Springfield & Otonga Road Roundabout

Detail design road safety audit

Report prepared for
Rotorua District Council
July 2017

ROTORUA LAKES COUNCIL OTONGA ROAD AND SPRINGFIELD ROAD INTERSECTION INTERSECTION SAFETY IMPROVEMENTS	
STREET LIGHTING PLAN SHEET 2 OF 2	
PROJECT NO: 1608 (REV 1.000)	DRAWING NO: 2-25478.00
DATE: 2017-03-01	SCALE: ESS1 A

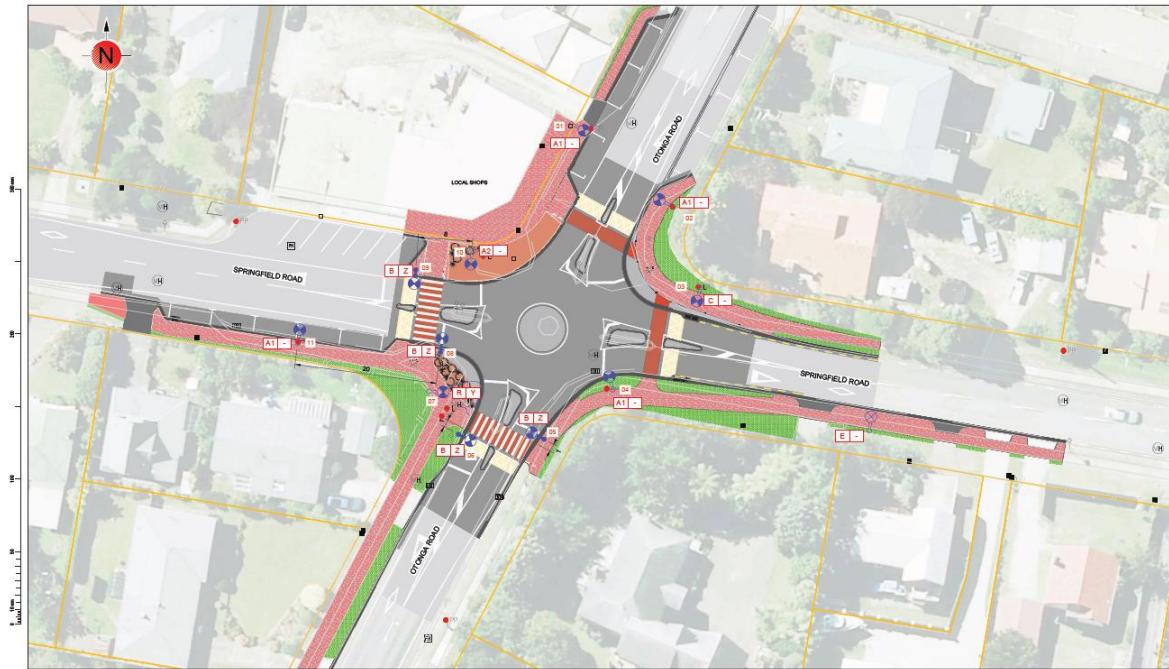
2.2.8. Sight lines at zebra crossings	Moderate
<ul style="list-style-type: none"> • Crashes are likely to be: Occasional • Death or serious injury: Likely • Risk ranking: Moderate 	
<p>Sheet E051 indicates that streetlights will be located directly in front of the pedestrian entry point on the approaches to both zebra crossings. The street light poles will restrict intervisibility between drivers and pedestrians waiting at or approaching the crossings.</p>	
Recommendations:

2.2.8.1.	Relocate the streetlights (4) to the departure side of the crossings and ensure that the standard of lighting is still achieved for the roundabout and crossings.
<p>Designer Response: A Street Lighting Design was undertaken for this Project, and the Lighting Engineers specified the positions of the street lights in accordance with the relative lighting design standards. In addition the Pedestrian Planning and Design Guide, Chapter 17 advises the following “For other pedestrian crossing points, RCAs should place floodlights on the approach side(s) to better illuminate pedestrians using the crossing [82]. This should be done by:</p> <ul style="list-style-type: none"> • identifying the pedestrian crossing points that are used at night • identifying the risks to pedestrians at each location • identifying the current lighting levels at each location • ranking locations by these three criteria and improving the sites with the greatest need. <p>Designer recommends no change to Design</p>

Safety Engineer: <i>Accepts Designers response</i>	
Client Decision: <i>Accepts Designers response</i>	
Action Taken: Click here to enter text.
